MEMORANDUM

SUBJECT: CDR-18-003 – Lorson East – Fontaine Blvd.
First Submittal

CONSTRUCTION PLANS
FOR
FONTAINE BOULEVARD & LAMPREY DRIVE
WITHIN LORSON RANCH EAST
STREET, STORM SEWER,
AND WATERMAIN CONSTRUCTION PLANS

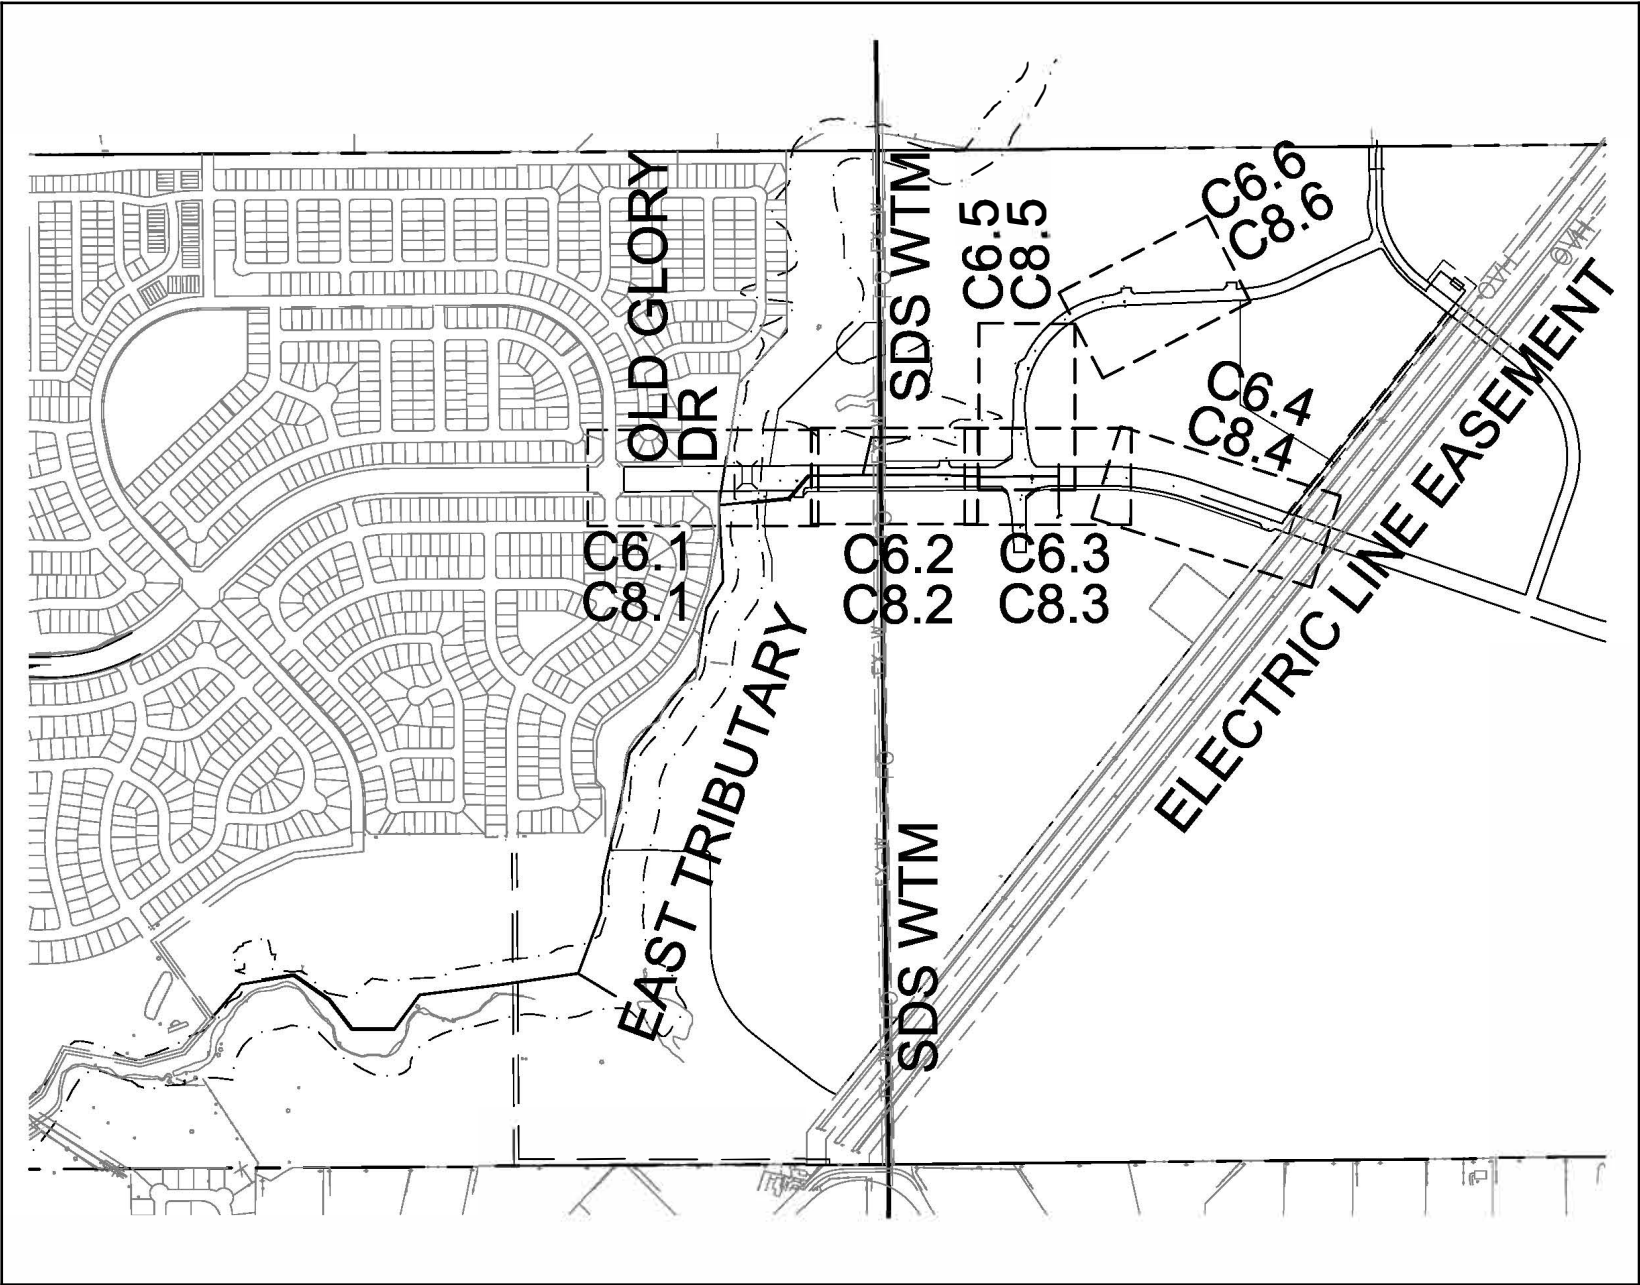
Subject: Callout
Page Label: 1
Lock: Unlocked
Status:
Checkmark: Unchecked
Author: dsdrice
Date: 2/15/2018 1:07:01 PM
Color: ■

Reference Lorson Ranch East EGP ESQCP number.

pud number inserted

C5.2

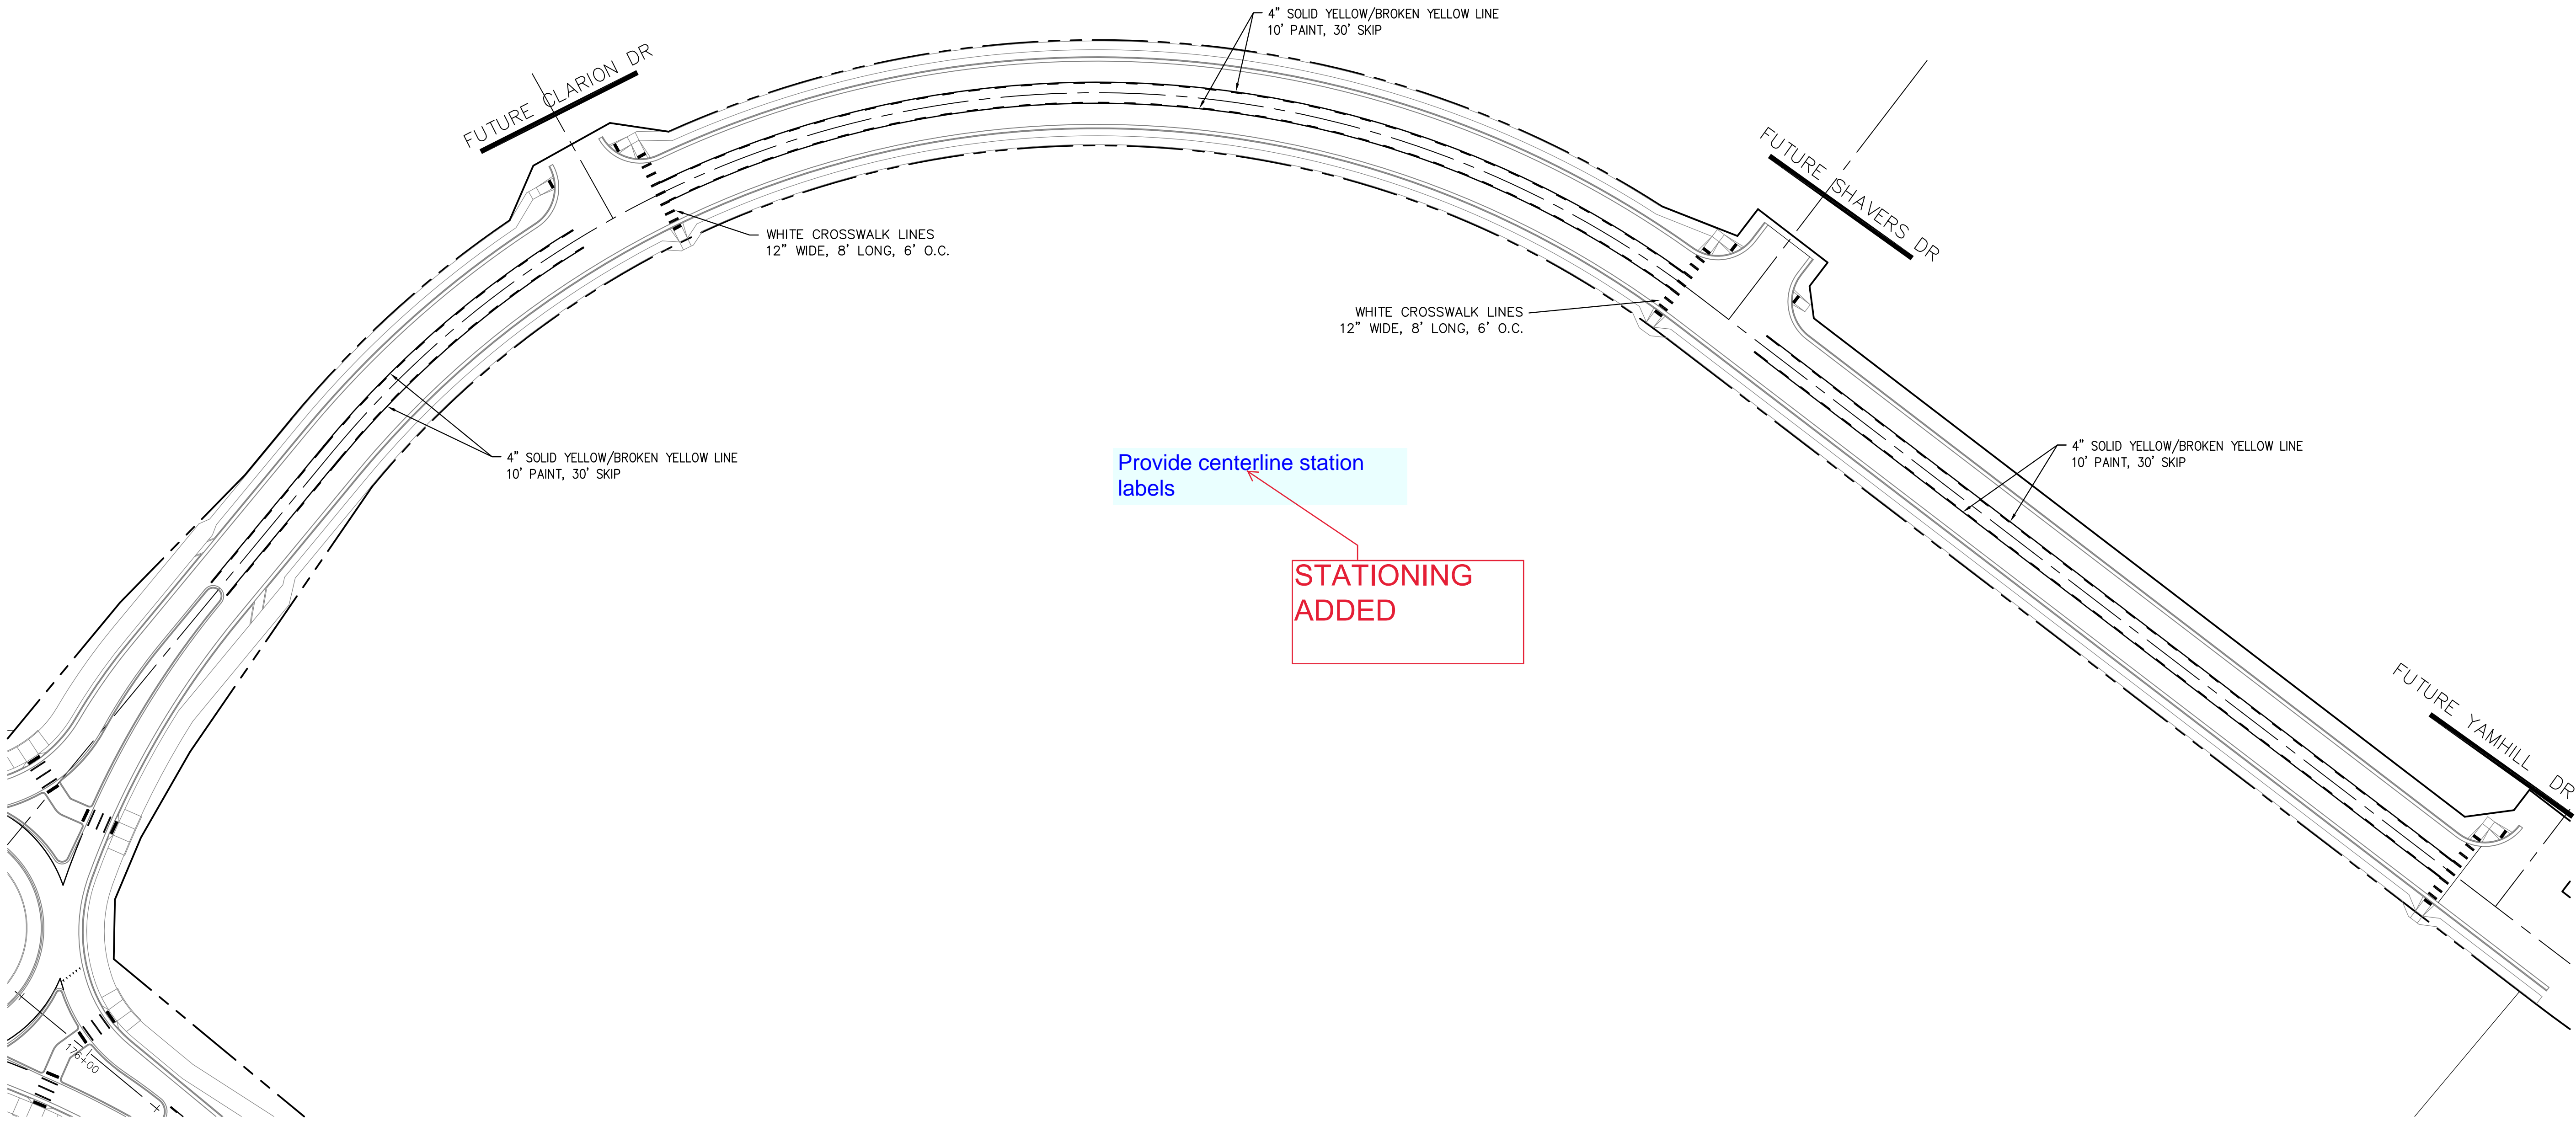
Provide centerline station
labels

STATIONING
ADDED
